Subject: Deflector-angles at the C.G. release
Usage of connection ring pair meeting standard LN 65091

Affected: All glider manufactured by Glasflügel

The technical content of this
TN No. 5-2018 is EASA approved.

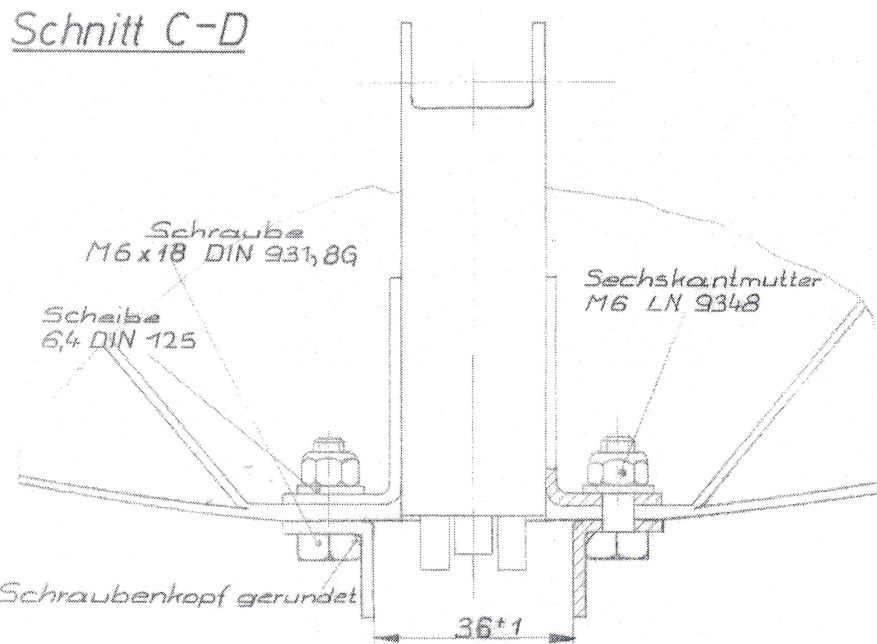
Reason: Jamming of the double-ring pair between the deflector-angles at the C.G. release.

1. Verification of the distances and the parallelism of the deflector-angles by means of a caliper or gauge with 36 mm width as shown in the attached drawing
2. If the distance between the deflector-angles is less than 36 mm, remove the deflector-angles and file the holes till the distance is right.
Pull the deflector-angles with a distance-piece of 36 mm together and support them with filling material as resin with cotton flocks or polyester putty. Positioning it with the screws. After curing, screw the release and the deflector-angles as shown on the drawing.
Finally, a function test and release test must be done.
